Access Compliance Report

Public Rights-of-Way

(Curb Ramps)

Intersection ID: 10019990	Main Street: ARMORY_DR	Cross Street: N/A	Location: SE
ADA ID: F85A7D7F6156	Ramp Type: PerpDiag	Initial Pass/Fail: Fail	Overall Compliance: No
Codes/Mitigation Info/Possible Solution		Field Measurements/Component Compliance	
Severity Score: 25

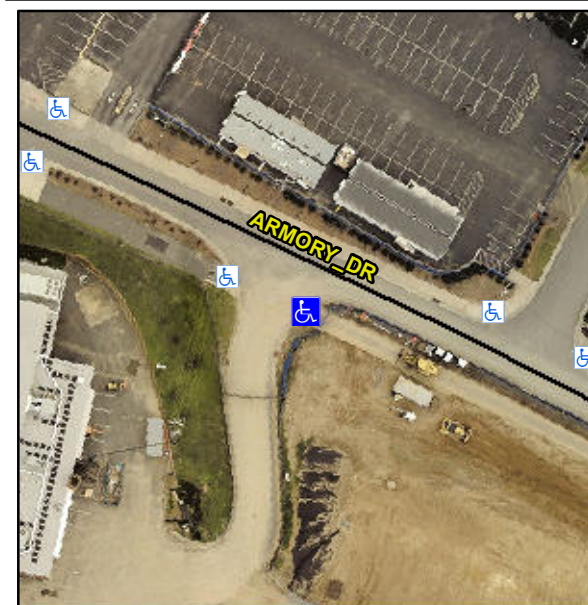
Not Found, R304.2.2, R304.5.3

Compliance	Description	Data	Compliance	Description	Data
N/A	Ramp Length (in)	51.0	No	Ramp Slope (%)	9.2
Yes	Ramp Width (in)	48.0	No	Ramp XSlope (%)	5.2
N/A	Flare Type LT	N/A	N/A	Flare Type RT	N/A
N/A	Flare Slope LT (%)	N/A	N/A	Flare Slope RT (%)	N/A
N/A	Flare Traversable LT?	N/A	N/A	Flare Traversable RT?	N/A
N/A	Landing Length (in)	N/A	N/A	DWS Provided?	N/A
N/A	Landing Width (in)	N/A	N/A	DWS Contrast?	N/A
N/A	Landing Slope (%)	N/A	N/A	DWS Length (in)	N/A
N/A	Landing X Slope (%)	N/A	N/A	DWS Full Width?	N/A
N/A	Landing Curb? (Y/N)	N/A	N/A	DWS Offset (in)	N/A
N/A	Shared Landing?	N/A			
N/A	Gutter Ponding?	N/A	N/A	Gutter Slope (%)	N/A
N/A	Gutter Lip Ht (in)	N/A	N/A	Gutter X Slope (%)	N/A
N/A	Painted X Walk1?	No	N/A	Painted X Walk2?	No
	X Walk 1 Direction	To NE		X Walk 2 Direction	To NW
N/A	X Walk 1 Width (in)	N/A	N/A	X Walk 2 Width (in)	N/A
	X Walk 1 Slope (%)	5.0		X Walk 2 Slope (%)	0.1
	X Walk 1 X Slope (%)	2.3		X Walk 2 X Slope (%)	2.9

Remove & Replace Curb Ramp With Two New Directional Ramps or Equivalent.
